## Shoalhaven Natural Resource & Floodplain Management Committee

## SN18.9 Technical peer review of the River Road Foreshore Shoalhaven Heads: Assessment of the Coastal Management Options Report by MHL.

**MHL2595 – Review of River Road Foreshore, Shoalhaven Heads:  
Assessment of Coastal Management Options Report**

Figure 1 – Qualitative Prioritisation of Management Works (Figure 5.1, WRL 2017)

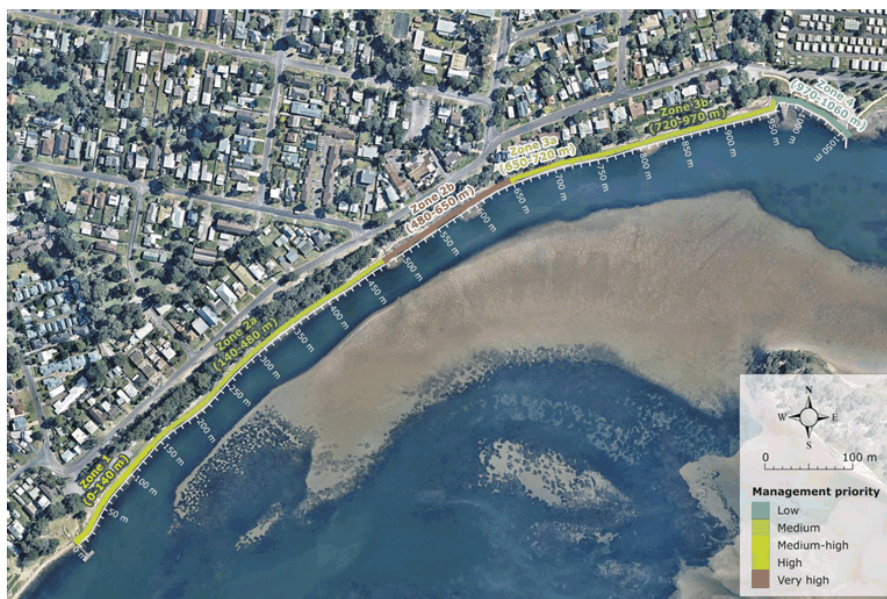
MHL considered that the recommended foreshore management approach is appropriate and feasible given the focus on addressing the immediate coastal hazards in the short term. Larger scale nourishment of the foreshore would be expected to provide a greater degree of beach amenity improvement along with coastal protection/resilience benefits to the foreshore, however the relatively greater degree of certainty in coastal protection provided by the recommended revetment option allows Council to reduce their immediate risk of further embankment erosion with a low maintenance semi-permanent solution. Notwithstanding the above comments, outflanking of the proposed embankment berm remains a possibility, albeit with a low probability, should broader channel migration occur. Sand won from activities relating to maintenance of the entrance flood notch may be used for periodic beach nourishment and may form part of a longer term management solution. This could include management of the subaerial berm height and width, as well as excavation of a sediment sink in the shoals behind the flood notch that may contribute to longer entrance opening periods. Monitoring of the effectiveness and impacts of flood notch and shoal maintenance works should be carried out to inform future management operations.
